UNITED STATES PATENT AND TRADEMARK OFFICE

APPLICATION NO.	FILING DATE	FIRST NAMED INVENTOR	ATTORNEY DOCKET NO.	CONFIRMATION NO.
10/787,188	02/27/2004	Yoshiki Takata	4699-0103P	4585
2292	7590	06/21/2006	EXAMINER	
BIRCH STEWART KOLASCH & BIRCH			CHOI, JACOB Y	
PO BOX 747			ART UNIT	
FALLS CHURCH, VA 22040-0747			PAPER NUMBER	
			2875

Office Action Summary

DETAILED ACTION

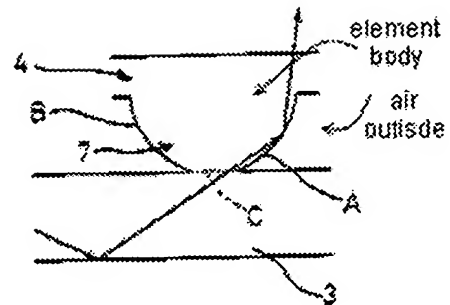
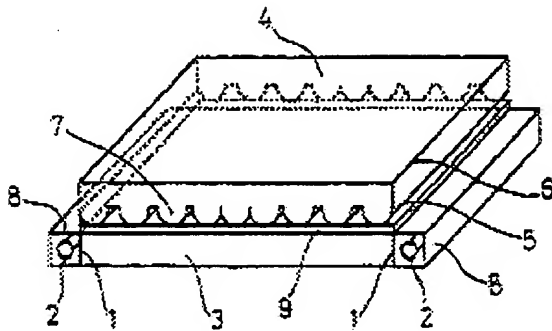
Regarding claims 1 and 8, Onishi et al. discloses an element body (e.g., 4) has a generally plate shape constituted with a material having a larger electric permittivity than air outside the element body and, in the inside of the element body, a plurality of *closed* spaces (e.g., Figure 10) are disposed whose electric permittivity is smaller (e.g., air outside) than that of the material constituting the element body and whose surfaces opposite to a radiation surface are generally flat.

Regarding claims 2 & 9, Onishi et al. discloses a plurality of *closed spaces* are disposed whose surfaces opposite to the radiation surface are generally parallel to the radiation surface (e.g., Figure 9).

Regarding claims 3 & 10, Onishi et al. discloses a plurality of *closed spaces* are adjacently disposed whose surfaces opposite to the radiation surface are generally parallel to each other (e.g., Figure 9).

Regarding claims 5 & 12, Onishi et al. discloses at least one member of the first member (e.g., 3) and the second member (e.g., 7) has recesses formed therein, and the recesses (e.g., A) are disposed to constitute the closed spaces by joining the first member and the second member.
